Piper Aircraft, Inc.
2926 Piper Drive
Vero Beach, FL, U.S.A. 32960

SERVICE NO. 1379A BULLETIN

Date: July 27, 2023

RUDDER INSPECTION

Figure 1
Rudder Assembly

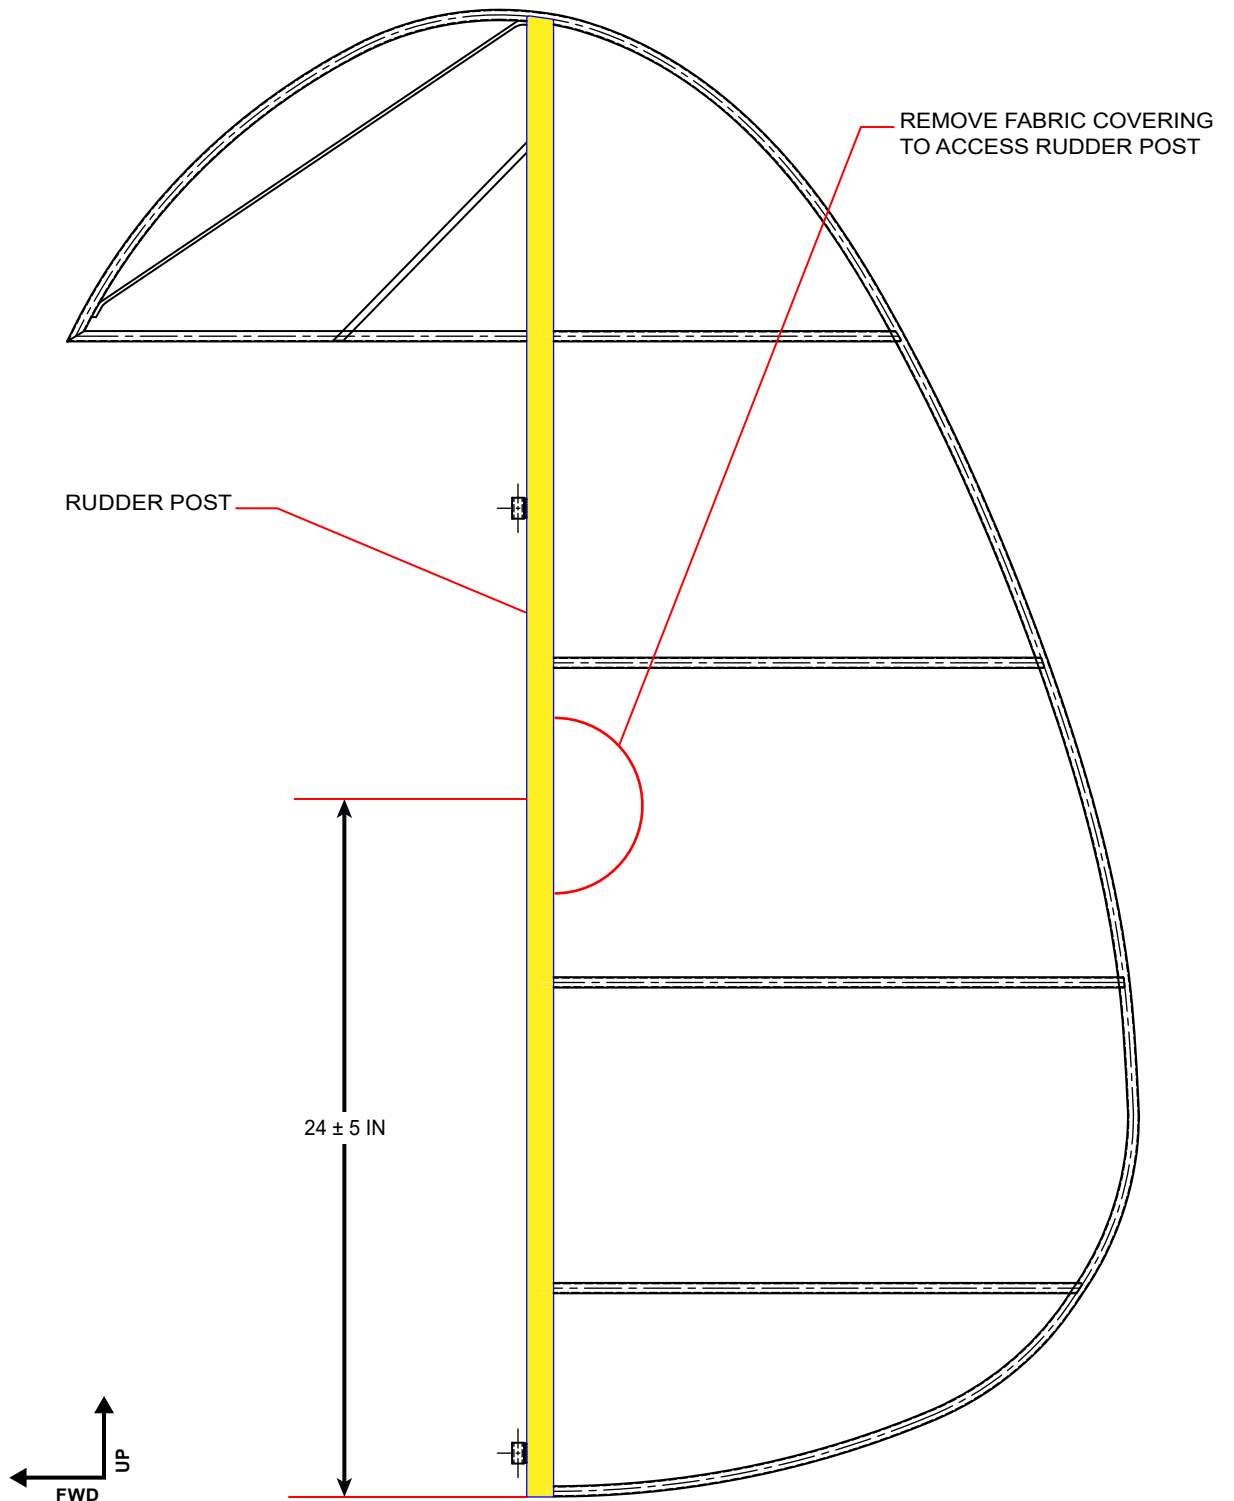
1. Remove the rudder from the aircraft and place on a flat horizontal work surface.
2. Mark the location along the rudder post according to Figure 1. Remove fabric covering to reveal a 3–5 inch length of rudder post tube. Using 220-grit or finer abrasive paper, remove paint, primer and any visible corrosion, to achieve a bare metal surface free of contamination.
3. Solvent wipe area with isopropyl alcohol or acetone to remove any debris. Allow solvent to evaporate.
4. Obtain a small quantity of Certified ACS nitric acid (70% v/v). One possible source is Fisher Scientific under Catalog No. [A200-500](#).

5. Apply one drop of the 70% nitric acid onto the surface of the part. Do not allow nitric acid to drip/run. Observe the drop for a reaction, which, if it occurs, will be immediate.
 - If the drop remains clear, the rudder post is made from 4130N steel. No replacement interval applies. Proceed to step 6.
 - If the drop turns a yellowish orange or brown, the rudder post is made from 1025 steel. In this configuration, the rudder is subject to a replacement interval. Proceed to Part II.

6. Finish all bare metal surfaces as follows: Apply primer that conforms to MIL-PRF-85582 Type 1 Class C2, or any one of the primers listed in Table 1. Follow with a top coat of Axalta Imron paint, or other compatible paint.
7. Repair the portion of the fabric covering that was removed to accomplish this inspection.
8. Reinstall the rudder onto the aircraft.
9. Perform a functional check on any systems that were disturbed during this inspection.
10. Make a logbook entry documenting compliance with Part I of this service bulletin, specifically stating the results of this inspection.

1. Replace the rudder with a rudder that is known to contain a rudder post made from 4130N steel.
2. Make a logbook entry documenting compliance with Part II of this service bulletin.
